Access Compliance Report

Public Rights-of-Way

Intersection ID: 15605	Main Street: GREYSTONE_RD	Cross Street: SOUTH_BV	Location: SE
ADA ID: 87C54B9A898D	Ramp Type: Perp	Initial Pass/Fail: Fail	Overall Compliance: No
		Severity Score: 25

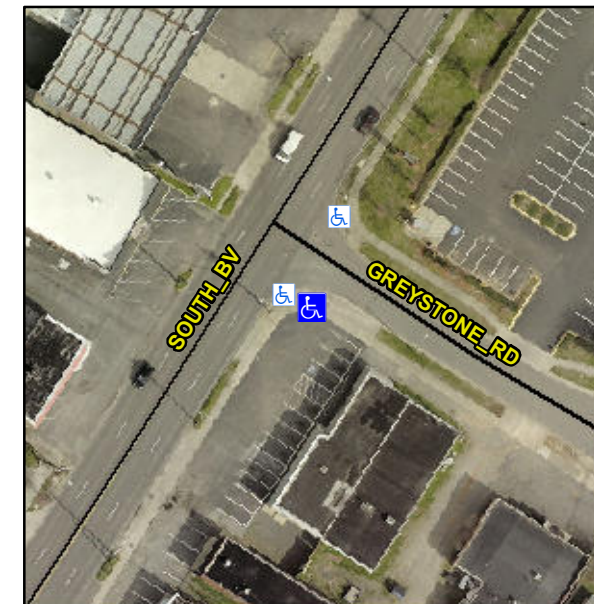
Not Found, R304.2.2

Compliance	Description	Data	Compliance	Description	Data
N/A	Ramp Length (in)	77.0	No	Ramp Slope (%)	14.2
Yes	Ramp Width (in)	52.0	Yes	Ramp XSlope (%)	1.3
N/A	Flare Type LT	N/A	N/A	Flare Type RT	N/A
N/A	Flare Slope LT (%)	N/A	N/A	Flare Slope RT (%)	N/A
N/A	Flare Traversable LT?	N/A	N/A	Flare Traversable RT?	N/A
N/A	Landing Length (in)	N/A	N/A	DWS Provided?	N/A
N/A	Landing Width (in)	N/A	N/A	DWS Contrast?	N/A
N/A	Landing Slope (%)	N/A	N/A	DWS Length (in)	N/A
N/A	Landing X Slope (%)	N/A	N/A	DWS Full Width?	N/A
N/A	Landing Curb? (Y/N)	N/A	N/A	DWS Offset (in)	N/A
N/A	Shared Landing?	N/A			
N/A	Gutter Ponding?	N/A	N/A	Gutter Slope (%)	N/A
N/A	Gutter Lip Ht (in)	N/A	N/A	Gutter X Slope (%)	N/A
N/A	Painted X Walk1?	No	N/A	Painted X Walk2?	N/A
	X Walk 1 Direction	To NE		X Walk 2 Direction	N/A
N/A	X Walk 1 Width (in)	N/A	N/A	X Walk 2 Width (in)	N/A
	X Walk 1 Slope (%)	2.5		X Walk 2 Slope (%)	N/A
	X Walk 1 X Slope (%)	1.2		X Walk 2 X Slope (%)	N/A

Remove & Replace Entire Ramp.
